**SUBJECT: LASALLE COUNTY STATION, UNITS 1 AND 2—SPECIAL INSPECTION  
TEAM REPORT AND EXERCISE OF DISCRETION; INSPECTION  
REPORT 05000373/2017009; 05000374/2017009**

Inspection Report 05000373/2017009, 05000374/2017009; 4/24/2017–07/21/2017; LaSalle County Station, Units 1 and 2; Special Inspection Team Report and Exercise of Discretion

SUBJECT: SPECIAL INSPECTION CHARTER FOR LASALLE COUNTY  
STATION HIGH PRESSURE CORE SPRAY INJECTION VALVE  
FAILURE

Figure 1 - As-Found Stem of Failed 2E22-F004 Valve

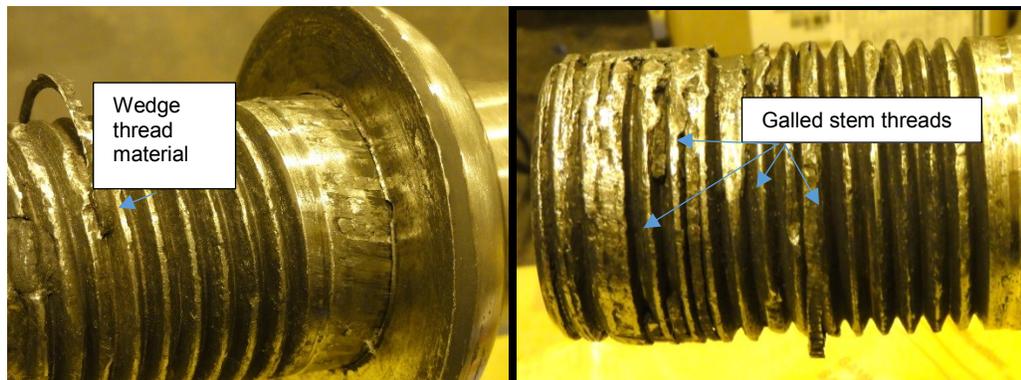
- On February 8, 2017, the valve stem was cleaned and lubricated. A stem rotation check was then performed during a scheduled refueling outage. The stem rotation check was verified to be less than approximately 5–10 degrees between the open and closed strokes. This met the procedural acceptance criteria.
- On February 8, 2017, a local leak rate test was performed using water with a differential pressure of 1000 psi gauge plus or minus 50 psi across the valve. The leak rate test passed with minimal leakage. System parameters indicated that the valve stem and wedge/disc were cycling without issue.
- On February 11, 2017, the valve stem was identified to have separated from the wedge during a system fill and vent activity. Pictures of the degraded stem and embedded wedge thread fragments are shown below.

- In February 2017, a 100 ton lift was used at near rated capacity to remove the wedge and disc from the seat. The 2E22-F004 valve was repaired using a new stem with an integral collar as compared to the pressed-fit collar on the original stem that shifted up as shown above. The new stem was pre-torqued into the wedge to approximately 7000 ft-lbs of torque.

Figure 2 - Threaded Connection Diagram Initial Condition

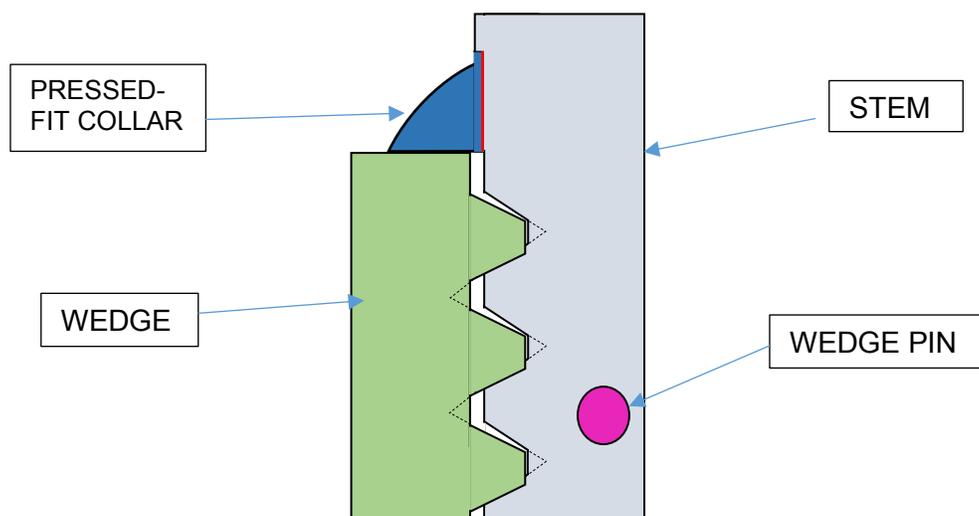
- **Initial Conditions.** The stem was manually threaded into the wedge with an initial preload that loaded the collar and put the stem threads into tension. The stem-to-wedge threaded connection was then pinned by drilling a hole through the wedge-stem-wedge. The initial installation torque and preload applied was very low and estimated to be less than 38,000 lbf based upon the pressed-fit collar capacity.

Figure 3 - Threaded Connection Degradation Diagram

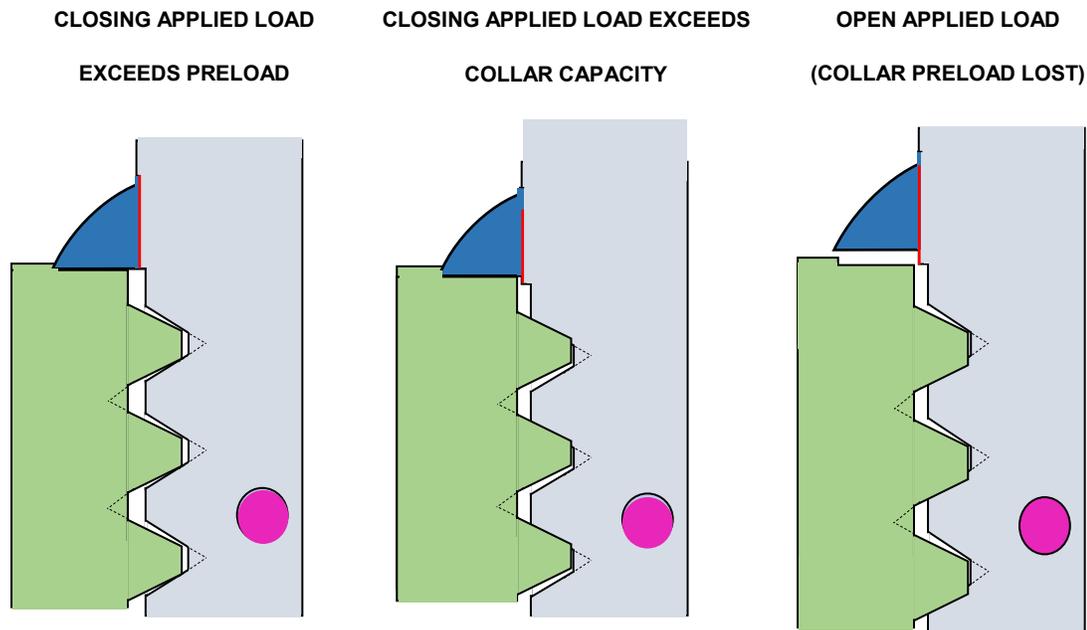
- **Collar Slip/Loss of Preload.** The normally applied closed thrust loads of over 200,000 lbf exceeded the pressed-fit collar load capacity, causing it to slip. Once the collar slipped, preload was lost.

- **Pin Shear.** After loss of preload, a portion of the axial loads were applied to the wedge pin, along with torsional loads, which exceeded the capability of the thread and collar friction. The subsequent applied torsional loads in the closing direction failed the wedge pin.
